Wilpinjong Coal Mine Expansion EIS

Assessment of Biodiversity Assessment Report and Biodiversity Offset Strategy (Hunter Eco) and supporting documents

David Paull 9 March 2016

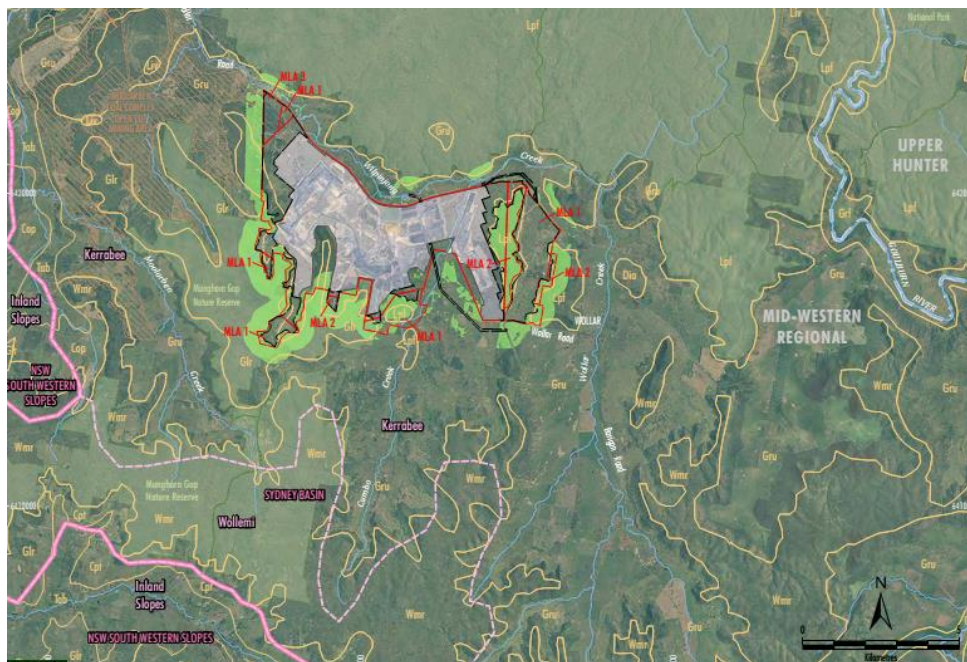
Biodiversity Monitoring Services (2013) describes that considering the dearth of sightings in the immediate and surrounding area it is unlikely that a viable population exists in or near Wilpinjong Coal Mine and that the single animal sighted was an individual moving between areas. Notwithstanding this statement, approximately 165 ha of potential Koala habitat is mapped on Figure 12.

The Biodiversity Monitoring Services (2013) report states that due to dearth of Koalas, no 'core habitat' is likely in the project area, however, the sighting of two Koalas in one of the offset sites prompted an assessment that this area was likely to contain 'core habitat'. Both areas contain the same woodland types, Grey Gum slope forest and lower slope red gum /yellow box/ Rough barked Apple.

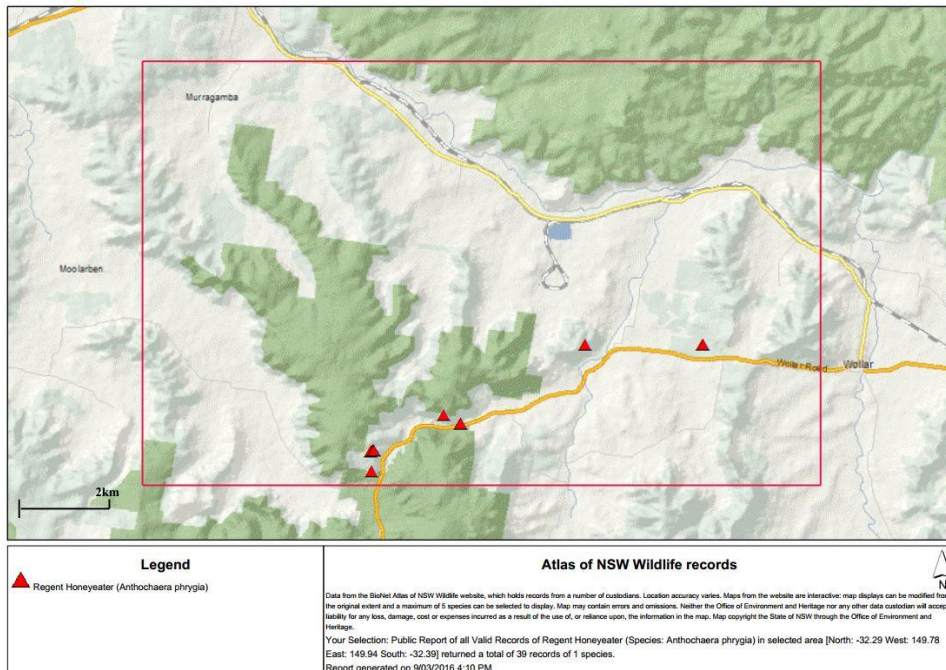
The location of the buffer Zones are indicated in Figure 4 of the Hunter Eco report (above) .It is presumed that the buffers represent areas of indirect impact from noise, light and dust pollution.

The proponent's buffer zone encroaches into the Munghorn Gap NR. This guideline is important as it reduces the effects of indirect impacts and avoids increased edge effect upon reserve system lands. This is particularly important for the Regent Honeyeater hotspots identified in the public database.
